Office Action Summary

10/718,221

GOH, KIM SEAH

DETAILED ACTION

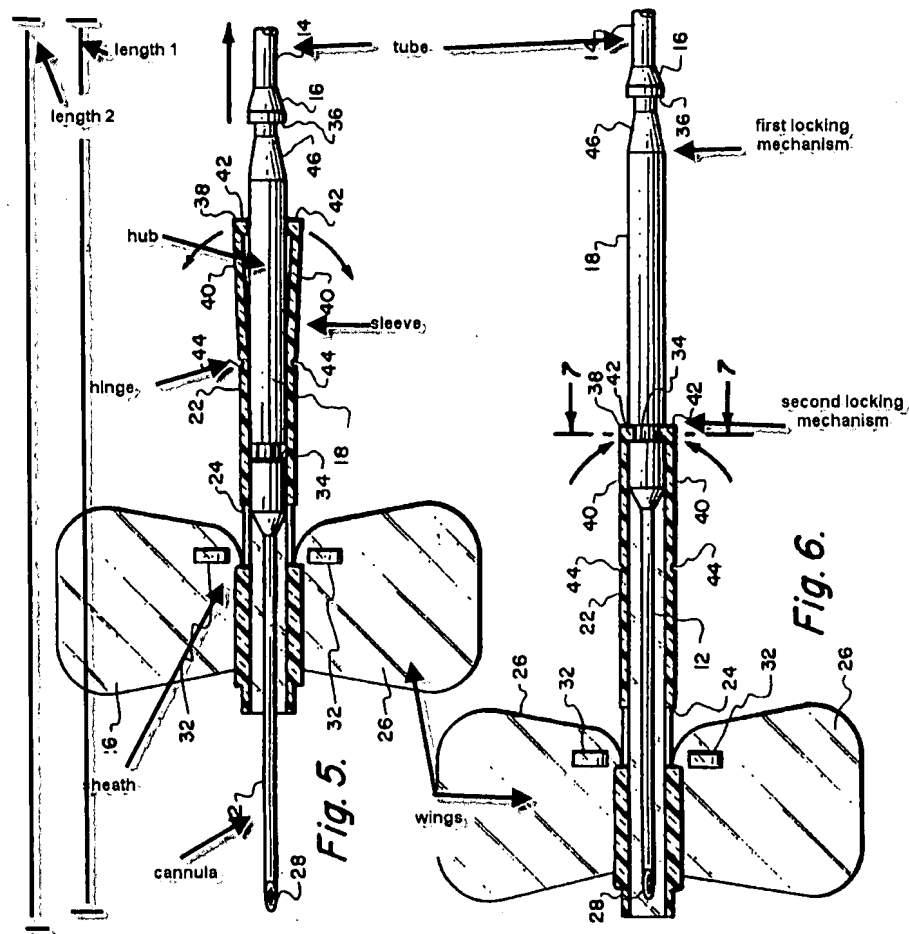
Regarding claims 1-2, 5, 10-12, 18-22, 25, 28 and 30, Lam discloses a telescopic winged safety needle assembly, comprising a hub (20) having a distal end, a proximal end (Figure 4), and an axial hole therethrough, a rotatable cannula (12) joined to said hub adjacent the distal end of the hub, a cylindrical sleeve (element covering 18, closest to 40) having a locking tab (near 42) attached thereto by a hinge (44), said cylindrical sleeve being axially disposed on said hub (Figures 5-6), a cylindrical sheath (see marked up drawing below, near 24) for retaining said hub therein and having a distal end and a proximal end, said hub being slidable along an interior surface of said cylindrical sleeve and sheath (emphasis added) (see Figures 5-6) from a first telescopic position (Figure 5) at which the distal end of said cannula joined to said hub projects beyond the distal end of the cylindrical sheath by a predetermined length, to a second position which is maximized in length (Figure 6) at which the distal end on the cannula is protectively covered within said cylindrical sheath, with said cylindrical sleeve being axially disposed on said proximal end of said cylindrical sheath (see Figures 1-6 and marked up drawing below), a pair of flexible wings (26) provided on the outer peripheral surface adjacent the distal end of said cylindrical sheath, a first and second locking mechanism comprising tabs and grooves, (near 46, 34) disposed on said assembly whereby the first locking mechanism releasably locks said hub, said sleeve and said sheath at the first position and a second locking mechanism that unreleasably lock said

hub, sleeve and sheath at the second position, with a tube (14) being attached to the proximal end of the hub (see Figures 1-6 and marked up drawing below).

Applicant's arguments filed 2/28/2007 have been fully considered but they are not persuasive. Applicant's Representative asserts that the Lam reference does not show the elements of the hub, sleeve, and sheath with the hub being slidable along an inner surface of said sheath and an inner surface of said sleeve. In Applicant's arguments, Applicant Representative summarily dismissed the Examiners rejection by examining the patent reference terms and not Examiner's interpretation of the reference and the claims of the application at hand. Examiner has included a marked up drawing of the specific elements in question, and the interpretation thereof. As shown in the drawings and highlighted in the rejection above the reference clearly shows the elements argued in their respective positions as currently claimed by Applicant, of specific note the sleeve being axially disposed on said proximal end of said cylindrical sheath and the assembly being maximized in length at a second telescopic position as indicated in the marked up drawings by the different associated lengths.
